City of Portland, Maine – Building or Use Permit Application, 389 Congress Street, 04101, Tel: (207) 874-8703, FAX: 874-8716

BUILDING PERMIT REPORT

DATE:(30/98	ADDRESS:	208-210 High St Rear	
REASON FOR PER	MIT: rebuild	drik		
BUILDING OWNER	B+6 M-9	17 minit Co		
	Bruce M.			
PERMIT APPLICAT	NT:	·		
USE GROUP	R-2	BOCA 1996	CONSTRUCTION TYPE 53

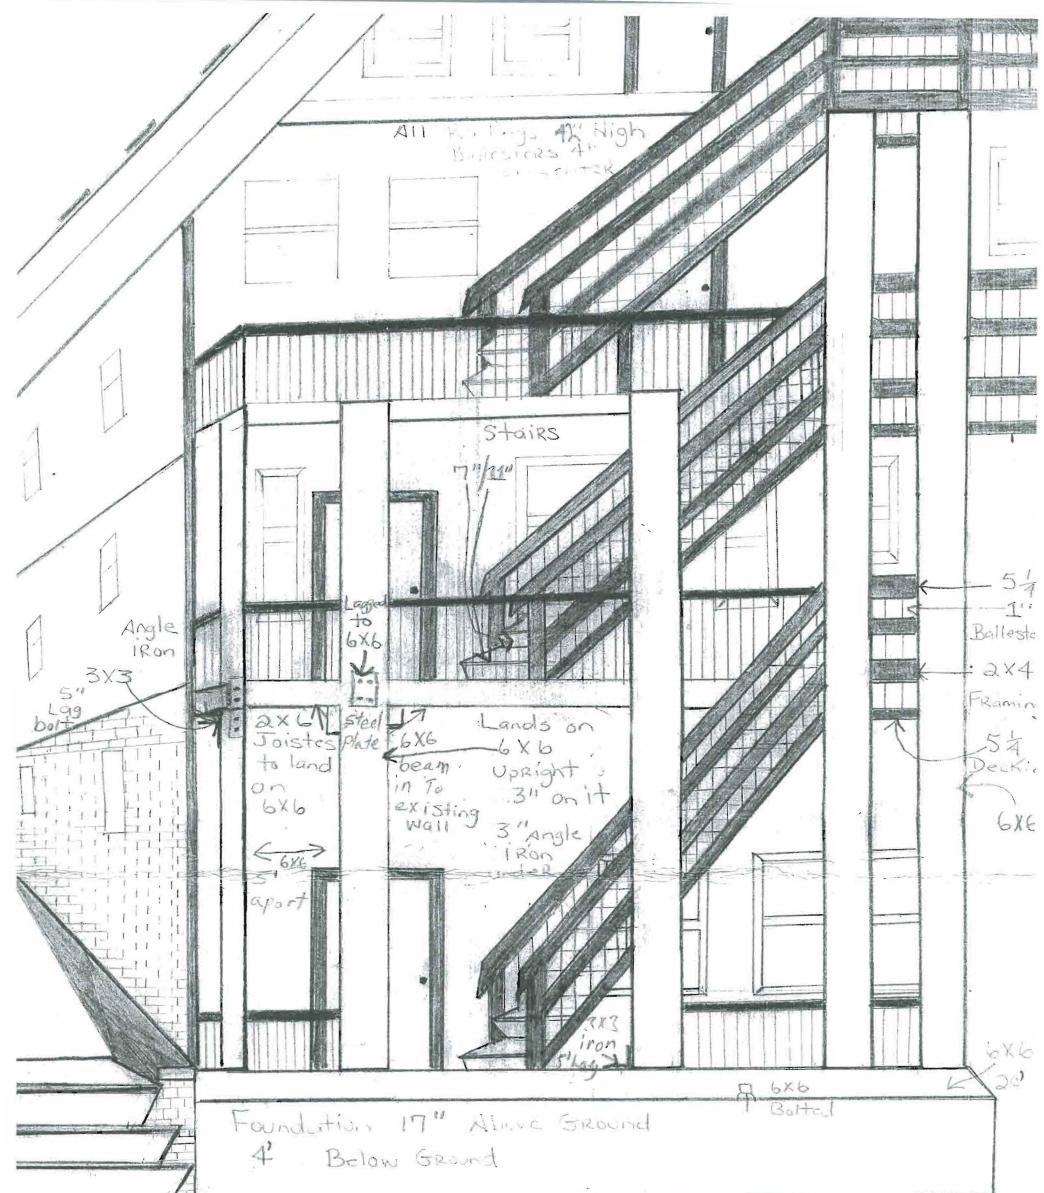
ter Let	tet the		Date	
called 8-27-99 Lolt wressand T call in Statics	Decide on 9/2/78 we visited the was made that Bob Marine will submit what is presently their and actualagem	The when the stairs are Replaced they will have to meet The Rize and Il'Tread Rule (TER)		Type	Framing: Plumbing: Final: Other:

- 29. Sicend means at excess shill be meintained doing construction:
- 1 Handrall shill be graspable 1/2-2" in diameter

*31. Proposed deck NOT TO exceed existing footprint
